CMD 23-M36.13

**Written submission from the
Passamaquoddy Recognition
Group Inc.**

Regulatory Oversight Report for
Canadian Nuclear Power Generating
Sites: 2022 and Mid-term update for
Ontario Power Generation's Pickering
Nuclear Generating Station

**To the Canadian Nuclear Safety Commission
Regarding the 2022 Regulatory Oversight Report (ROR) for Nuclear Power
Generating Sites**

Figure 1: Distances Between Header, the Liquid Relief Valves, the Degasser Condenser Safety Relief Valves and the Downstream Piping to Collection Tanks

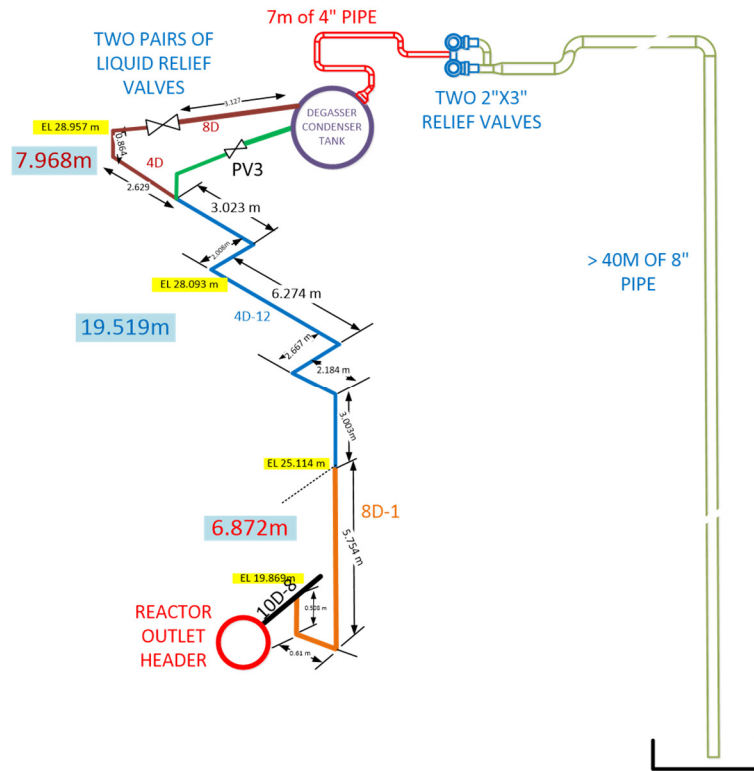
1. The safety relief valves downstream of the Degasser Condenser have a specified steam relief capacity of 4 kg/s. When tested, the actual relief capacity was lower than the specified relief capacity. For example, when tested in 2001 by OPG at Wylie Laboratories under the manufacturer Bopp & Reuther's supervision, the Pickering relief valve's combined steam relief capacity was 120 g/s for its two relief valves [11, 12]. The power of a single Darlington unit is 2776 MW_{th}, and the Bruce unit is 2832 MW_{th}, which is not too far from the Surry Nuclear Power plant. For Qinshan, the specified relieving capacity is of each valve is 26.66 kg/s at 268°C and 10.16 MPa(a).
2. The pressure relief valves in the operating stations in Canada are not close to the source of overpressure expected. As Figure 1 shows, they are several meters away from the headers.

3. The potential backpressure from the >40 m long piping downstream of the relief valves will significantly increase pressure. The pressure required to open the valves will exceed the pressure needed for the design.

Figure 1: Typical PHWR CANDU PHTS pressure relief – indirect and away from PHTS; discharge path interrupted by other valves, vessels & systems.

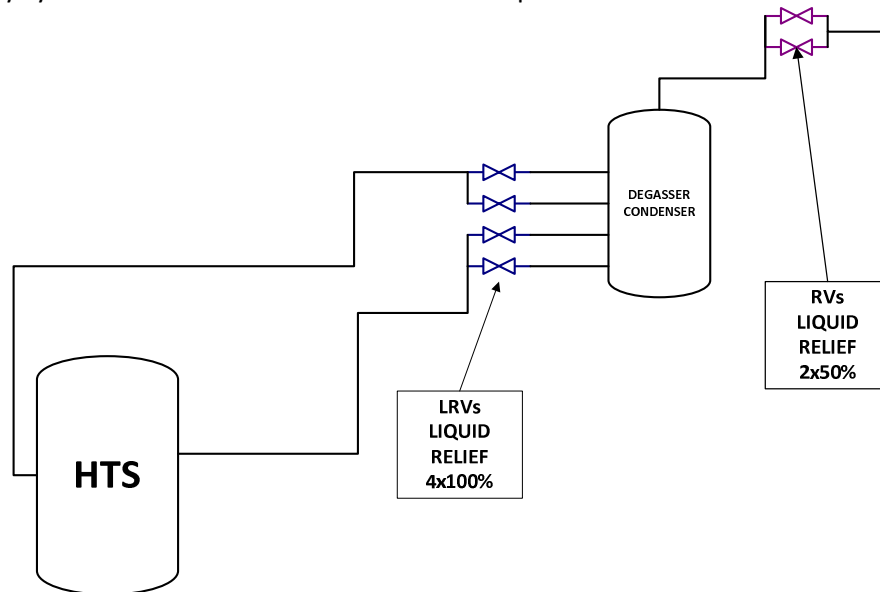
A schematic of the CANDU-6 overpressure relief system in Figure 1. In all CANDU design documents, LRVs are described as valves protecting HTS from over pressure, and the downstream Relief Valves (RVs) described as providing overpressure relief services to the degasser condenser. Practically speaking, the relief valves mounted ~7m downstream of the degasser condenser (Figure 3) are de facto PHTS relief valves and all discussion about relief capacity in this technical note is about these relief valves. LRV's are not relief valves in terms of their opening passively, proportional to overpressure. They are kept closed by pneumatics and open on pressure signals using a 48V actuator. They are adjusted to open a certain size to instill a certain pressure drop (25 psi in CANDU 6) at a certain subcooled water discharge (26 kg/s) through them. Note that even the LRV design basis is a reactor shutdown state (According to a CANDU 6 Overpressure protection report -Reference ⁱ, section 12.4.1.2– “The heat transport relief valve capacity was determined by considering postulated process failures which lead to pressurization of the Heat Transport System when the reactor is not at power”) and the downstream relief valves are also sized for a shutdown state and even a liquid swell relief capacity (0.036 m³/s) of the relief valves is much smaller than required by the stated design basis (Figure 2) to even remove liquid swell in a subcooled PHTS from decay heat.

Figure 2: Even liquid swell rate, the erroneous design basis is higher than valve relief capacity.

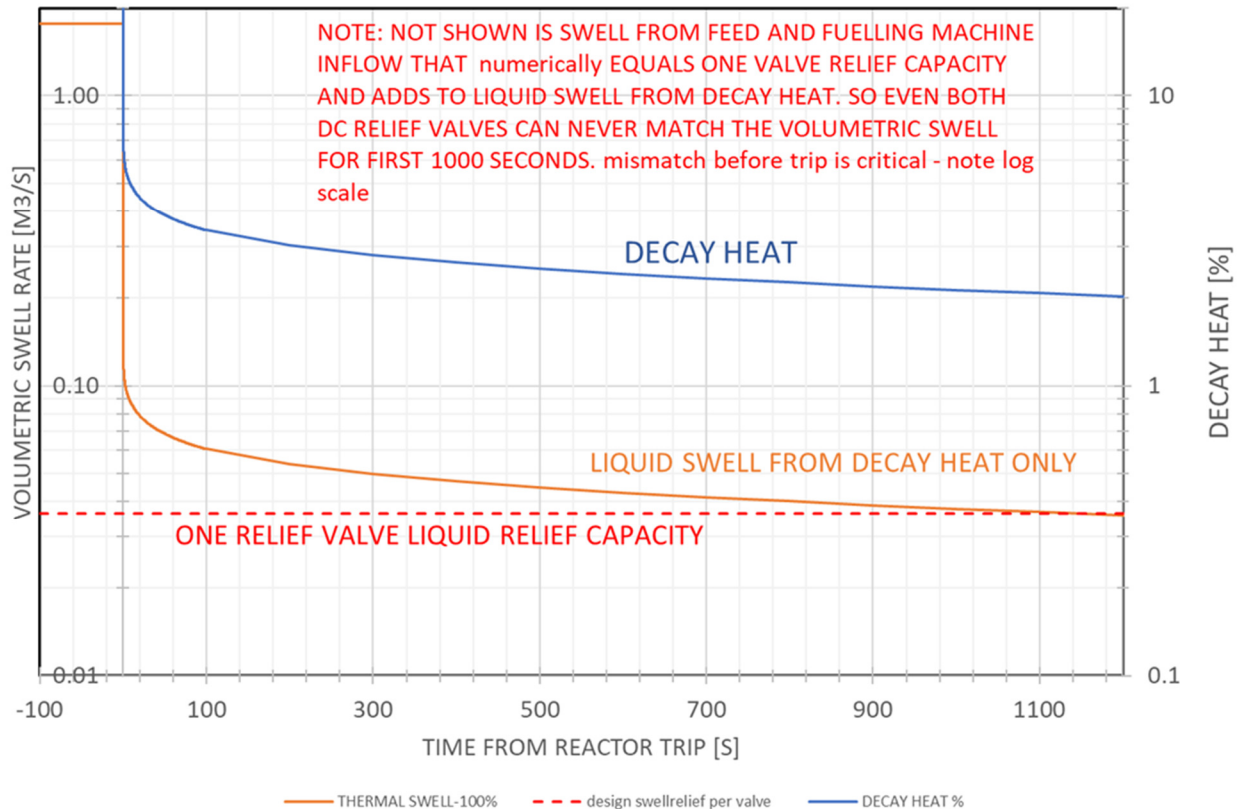
No other reactor overpressure relief valves specifications are based on a liquid relief capacity. Most have relief capacities based on 2 orders of magnitude higher steam relief capacity than has been for CANDU reactors.

Figure 3: Overpressure protection system layout at a CANDU-6 plant

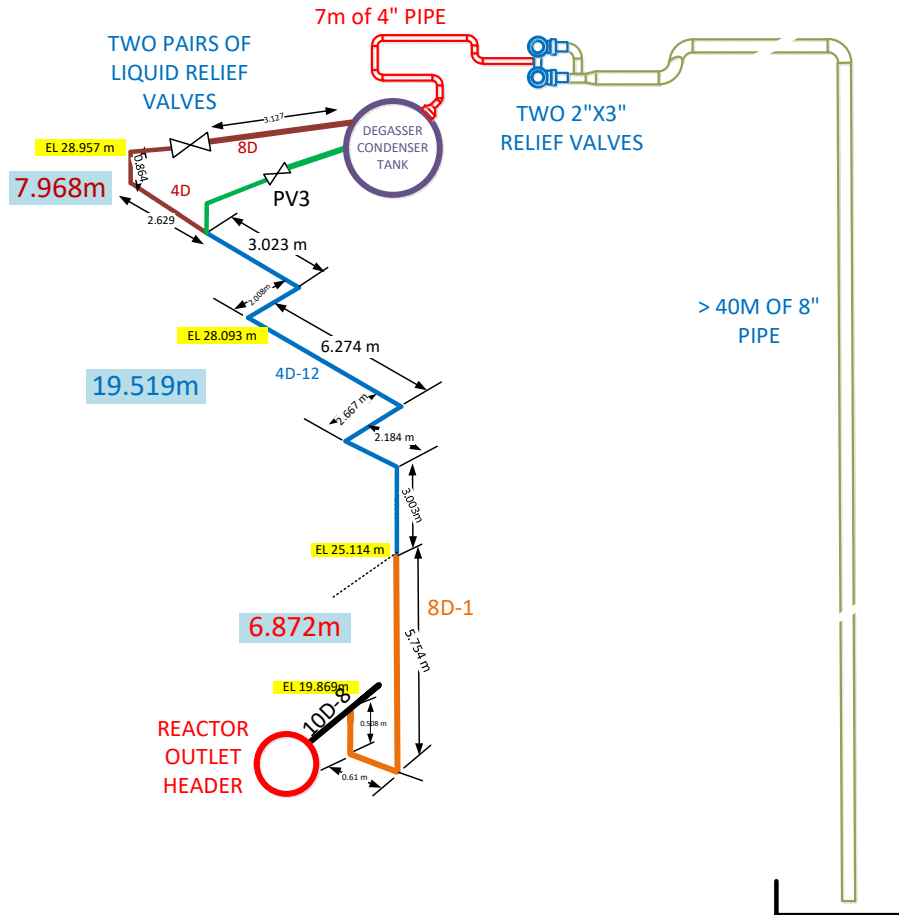
The CANDU pressure relief valves (RVs) are typically located ~7m downstream of degasser-condenser vessels which are themselves located over 30m away from reactor headers with intermediary power operated valves (LRVs) near their inlet (Figure 3). As a result, the pressure-drop over these pipe distances of ~40m for the required relief rates for inlet saturated water or steam far exceeds the allowable magnitudes and likely to cause an undesirable overpressure in the primary heat transport system. The additional, long ~30m path from the relief valves to the basement sump presents additional back pressure likely to reduce the valve mass & energy relief capacity.
